AP1000 DOCUMENT NO. APP-GW-GLR-134	REVISION 1	PAGE 1 of 470	ASSIGNED TO W-Sterdis	OPEN ITEMS (Y/N)
----------------------------------------------	----------------------	-------------------------	---------------------------------	------------------

TITLE: AP1000 DCD Impacts to Support COLA Standardization

AP1000 Standard Combined License Technical Report

AP1000 DCD Impacts to Support COLA Standardization

Figure 3.8.2-4 (Sheet 5 of 6)

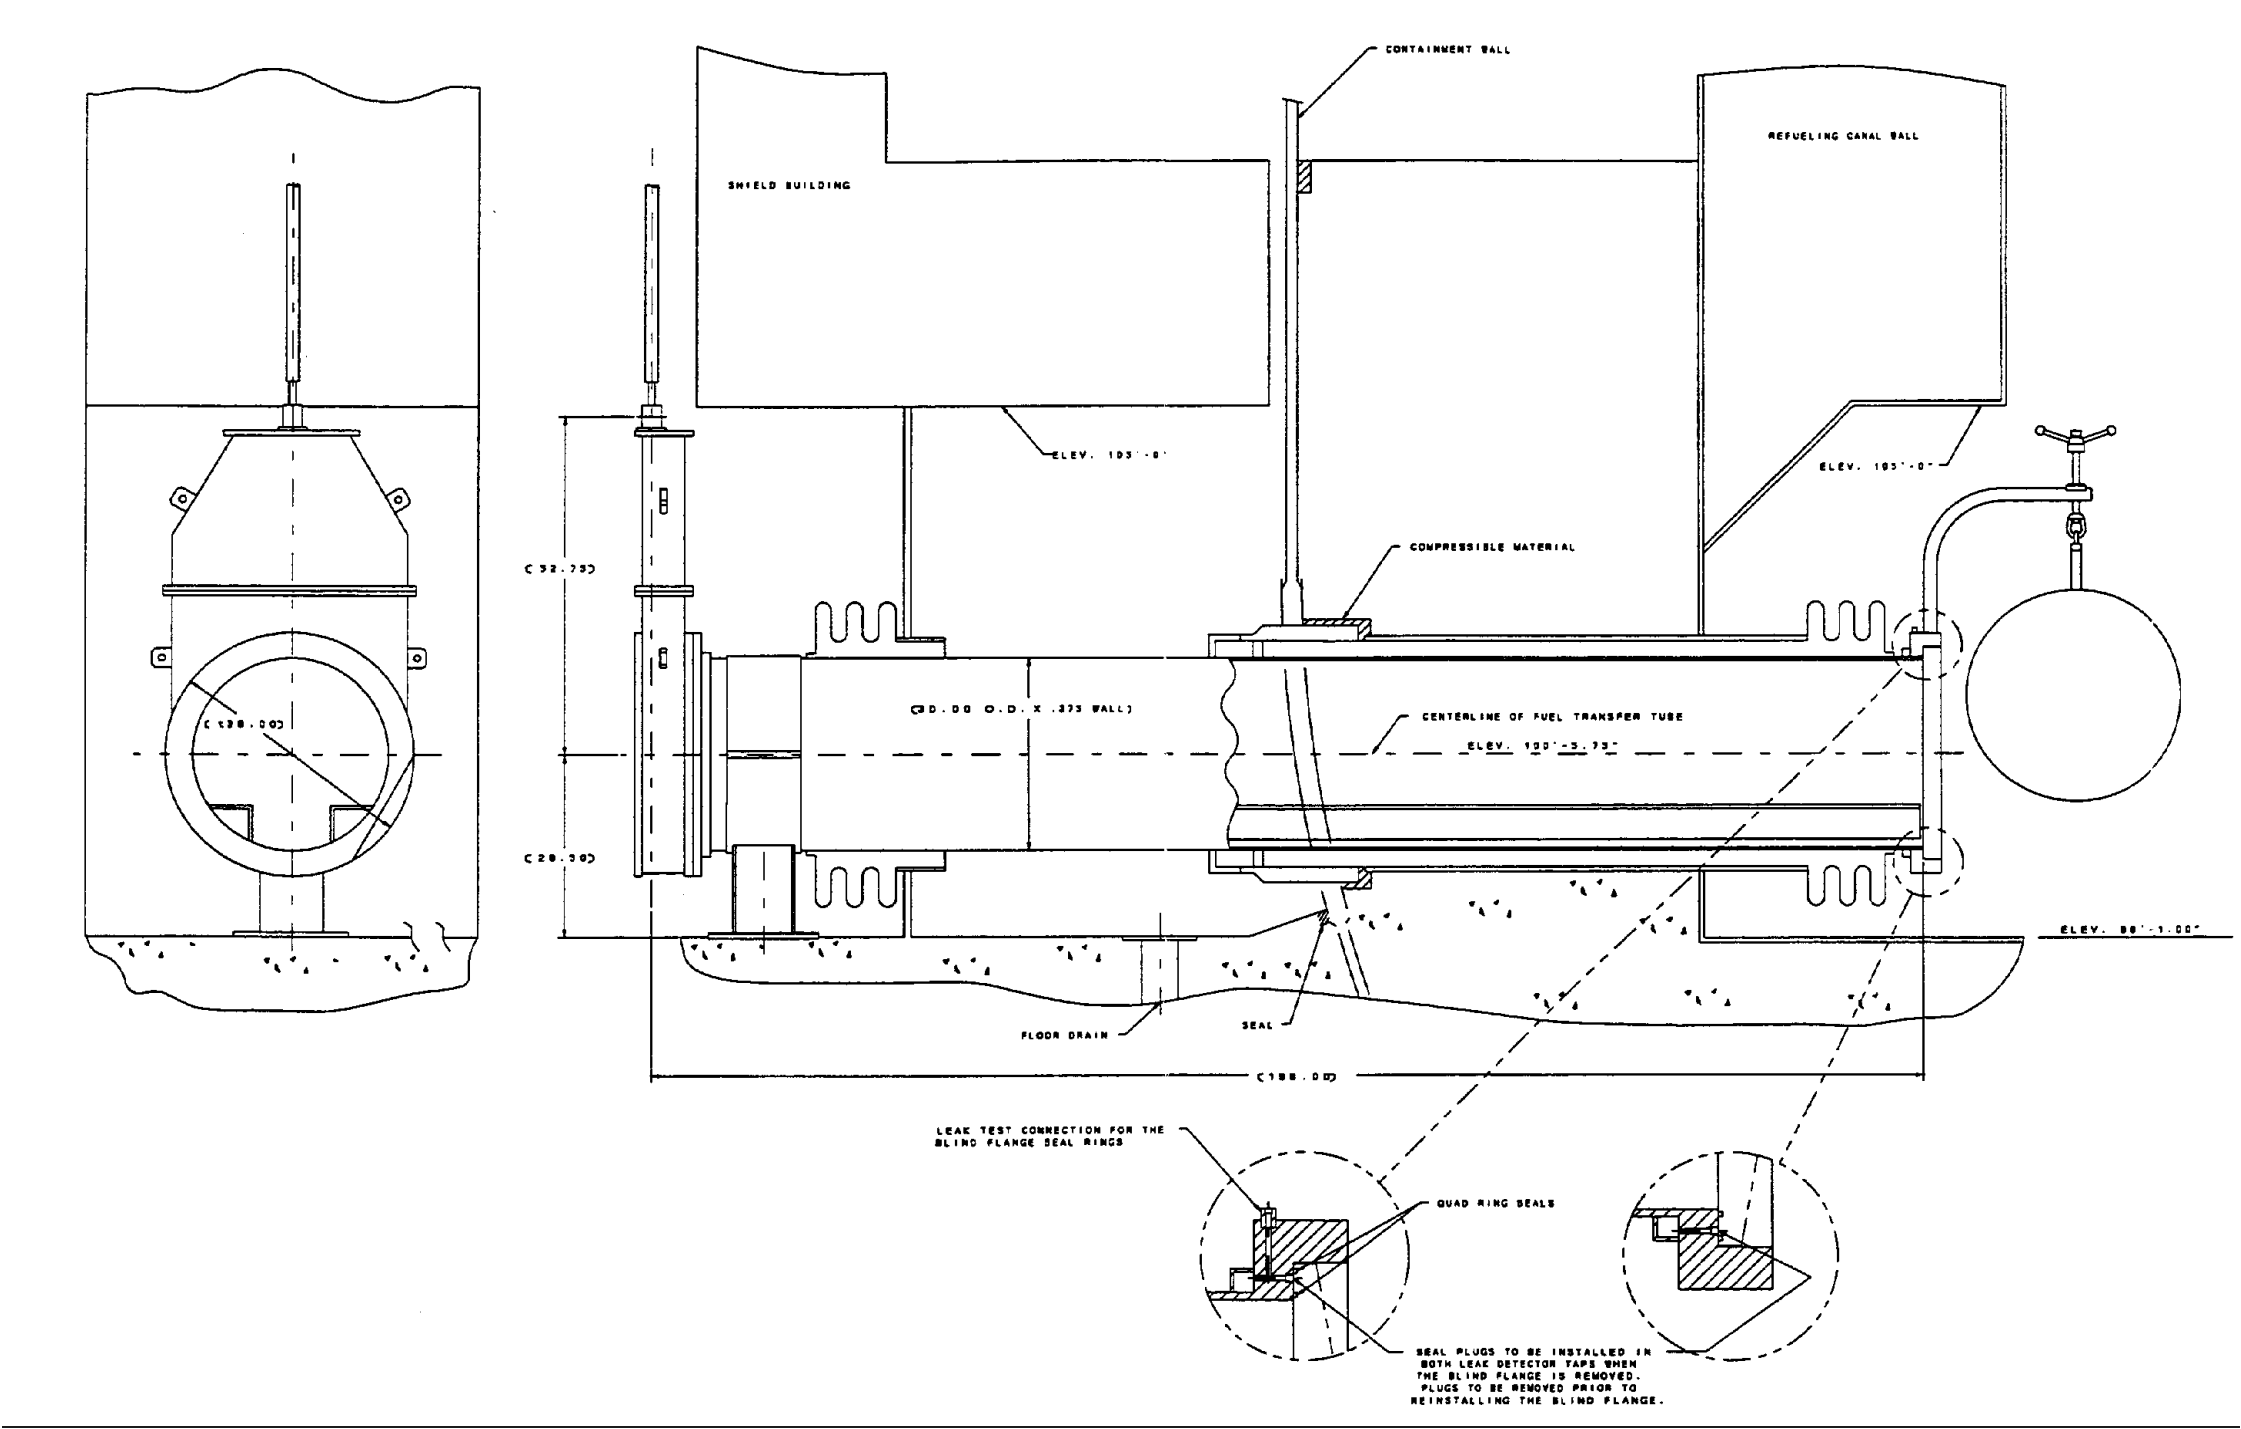
NRC044 contains corrections to Table 3.2-3, Figure 3.8.2-4 of DCD Revision 16. The basis for the change is RAI-TR09-003.

Figure 3.8.3-6 (Sheet 1 of 4)

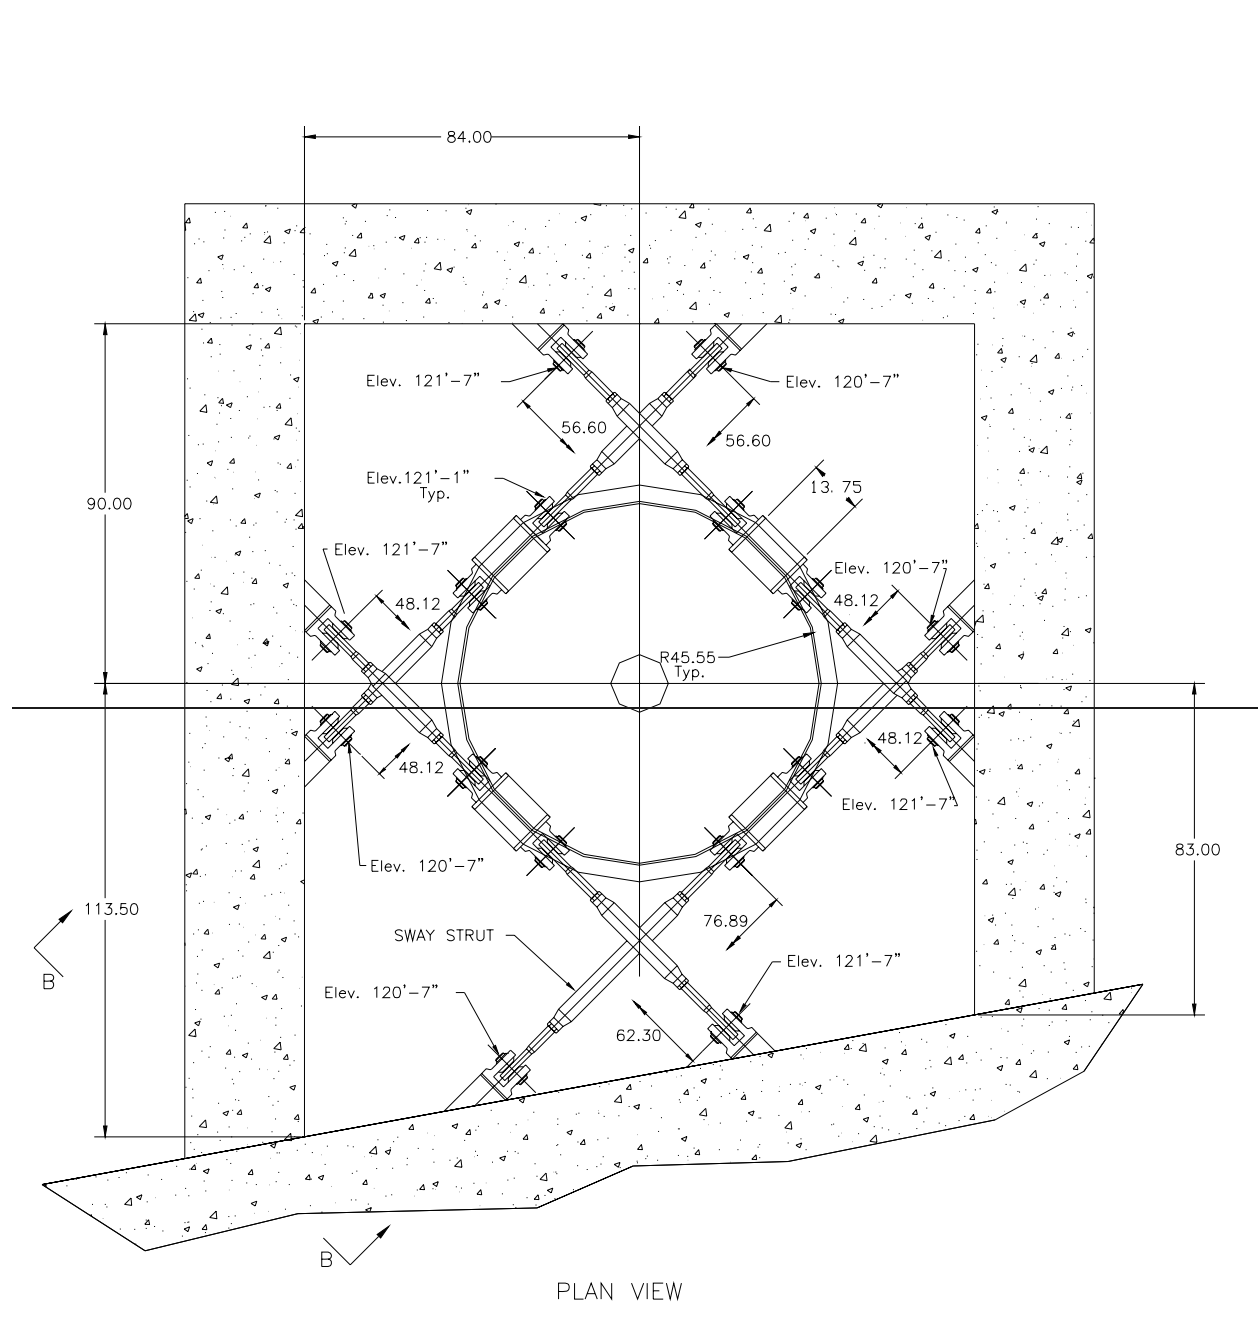
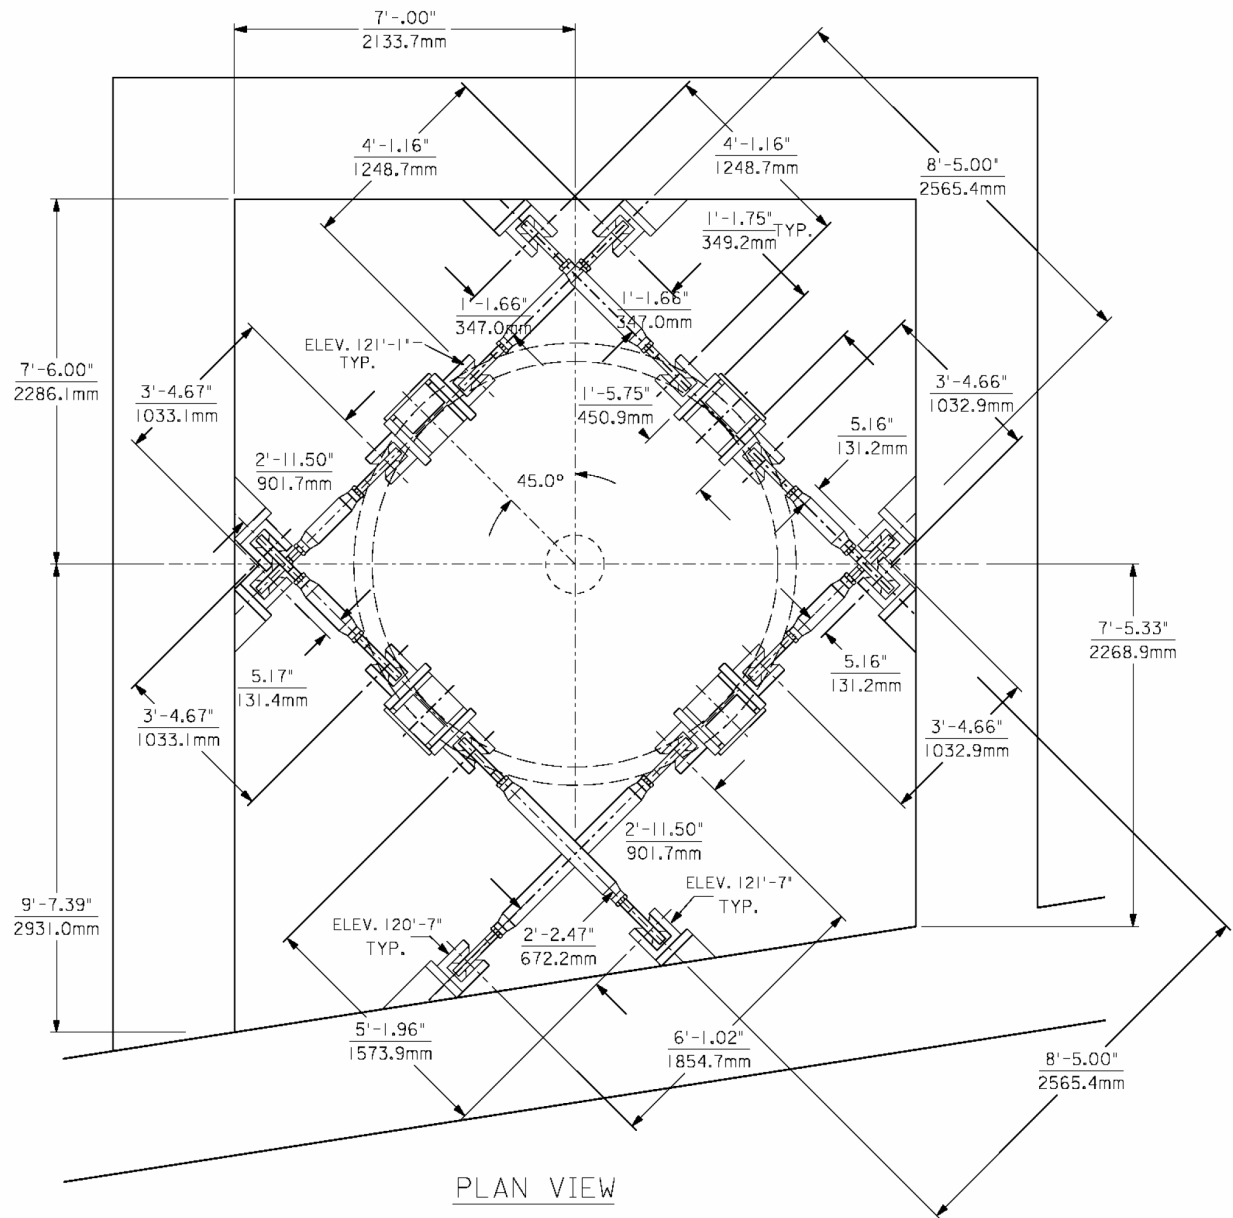
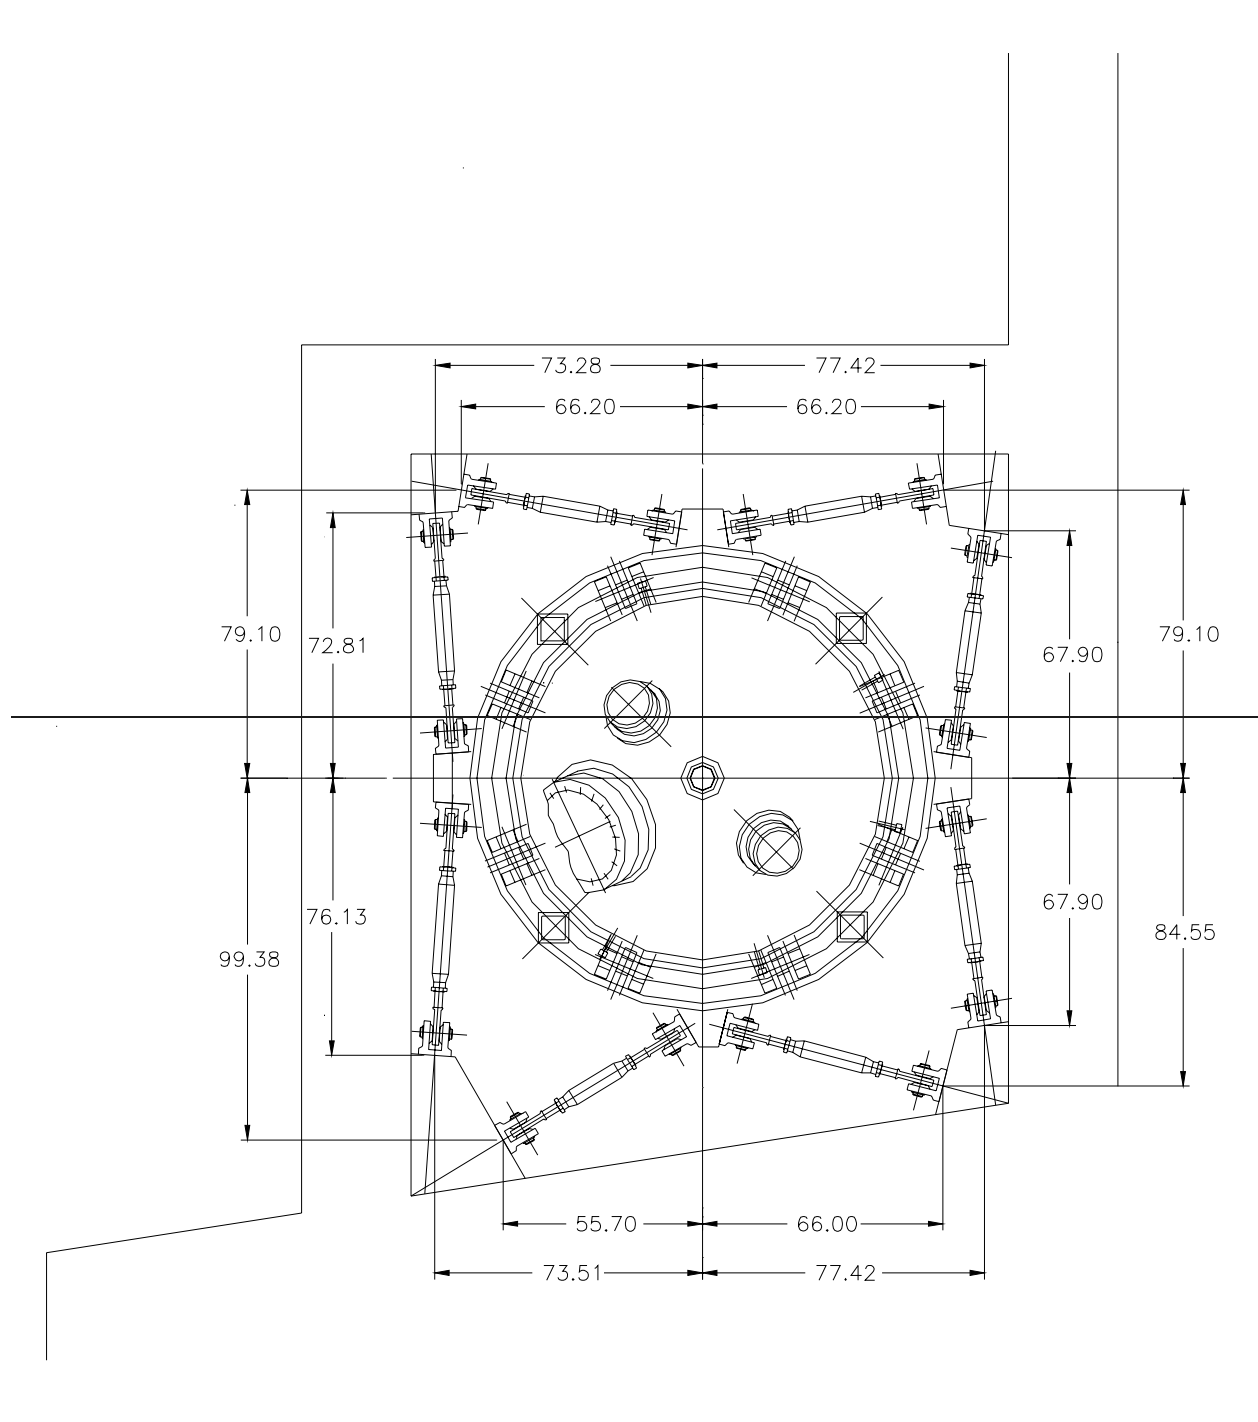
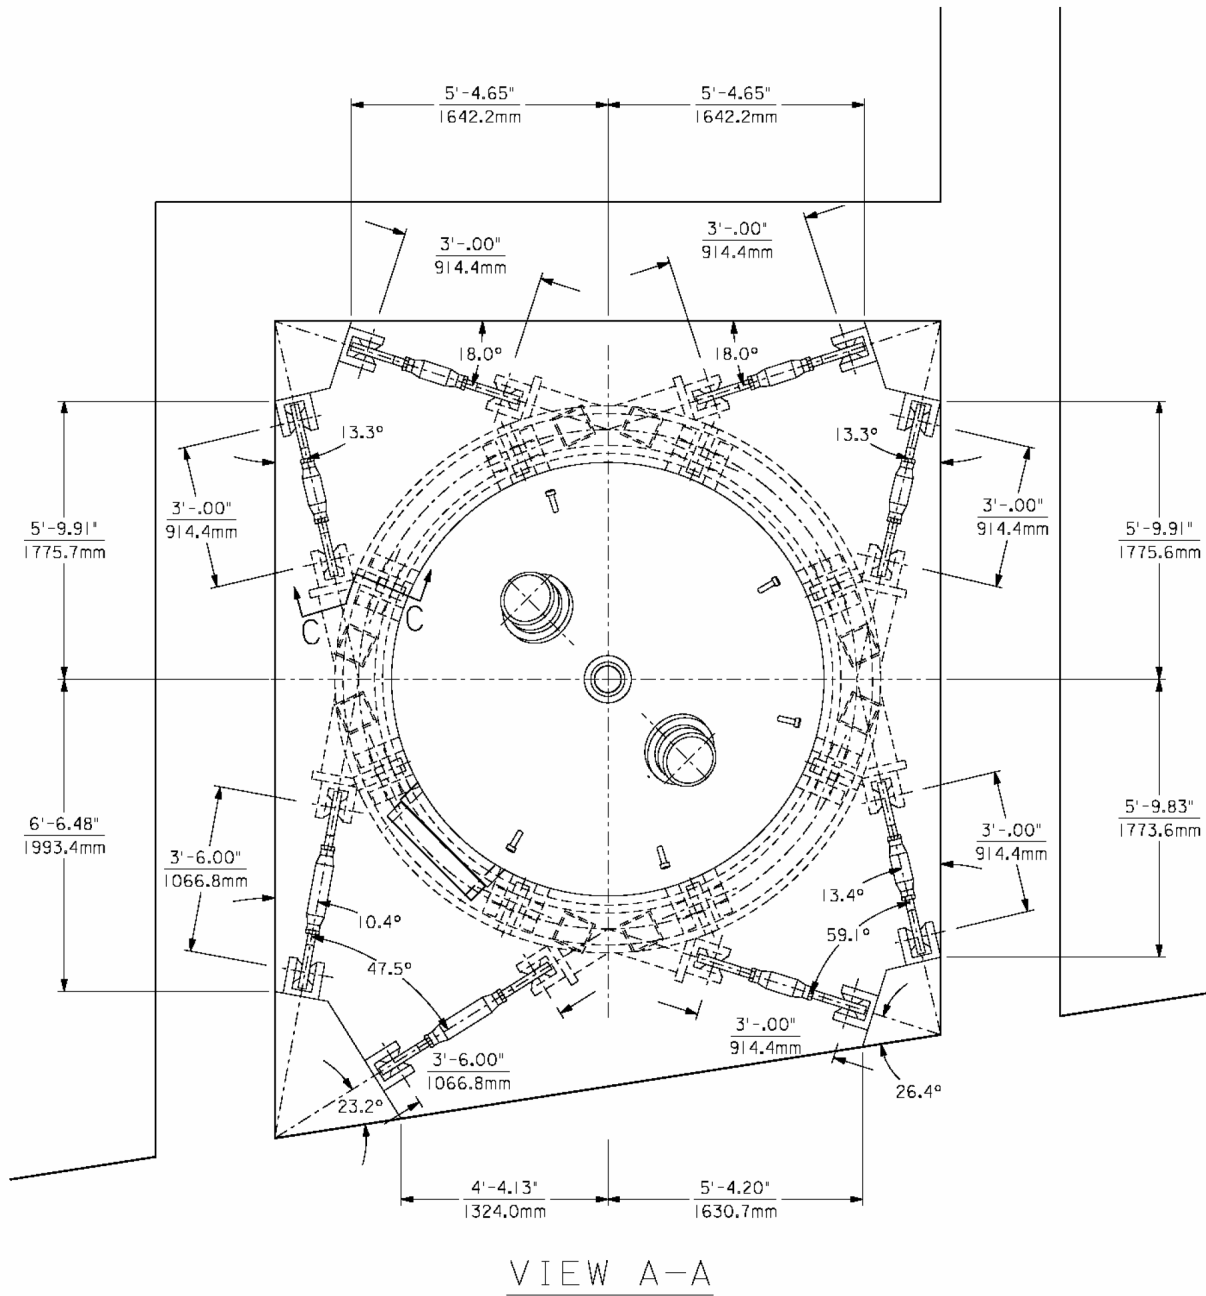
NRC 097

Figure 5.1-2

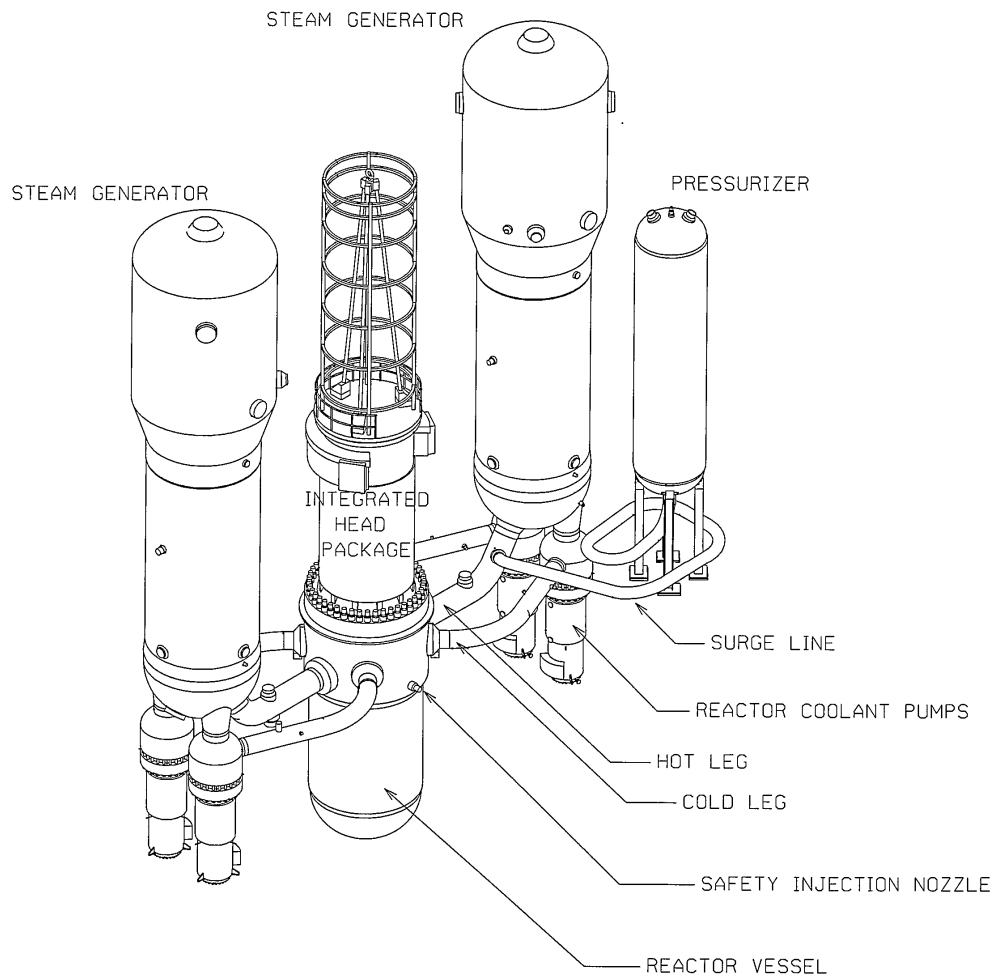
NRC106 contains corrections to Figure 1.2-1, 5.1-2 and Figure 1.2-9. The basis for the change is TR36 APP-GW-GLR-016.
